SUZUKI

Service Bulletin

Subject: OIL TANK CAP VENT

Bulletin No: GENERAL-13

CORRECT INSTALLATION

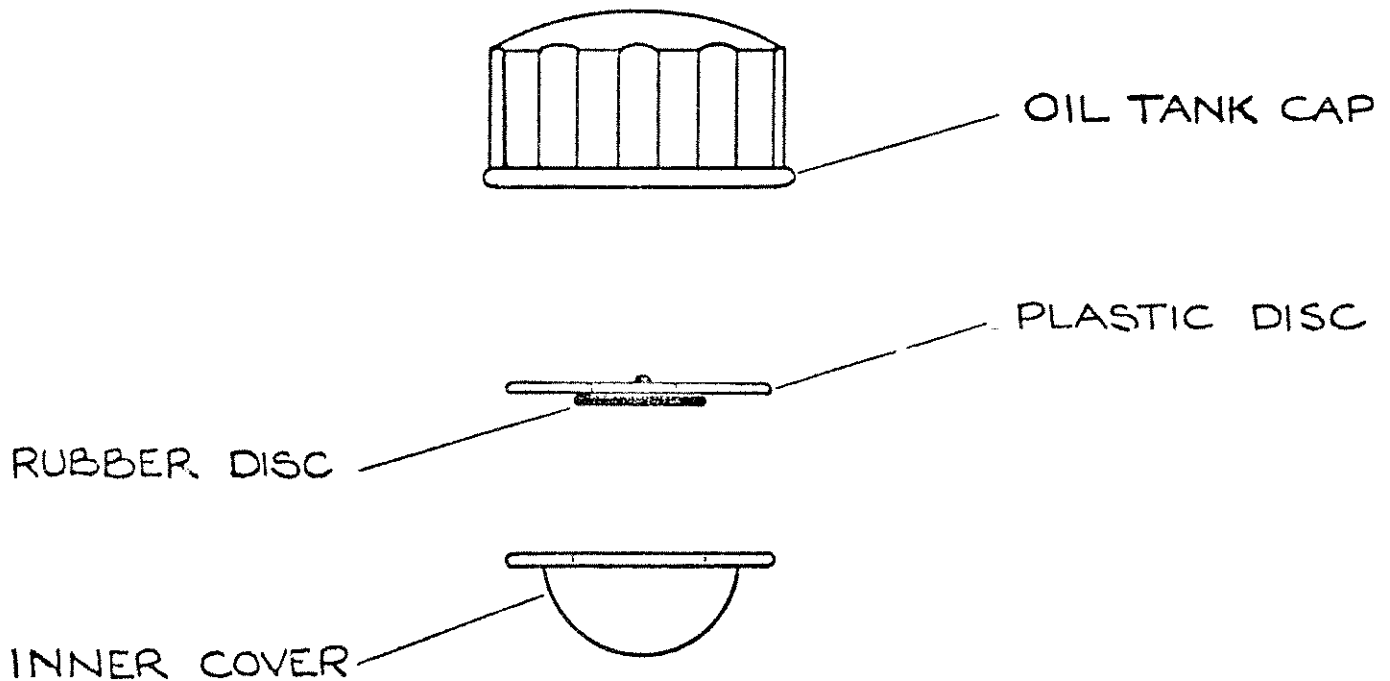
There is a possibility that certain units of earlier models may have the breather valve in the oil tank cap installed incorrectly by the owner.

As illustrated below the flat rubber disc should be on the tank, or lower side, of the white plastic breather plate.

Please check the installation of this item on all applicable models that you may service. Obviously, failure to correct this problem could result in oil starvation and possible engine seizure.
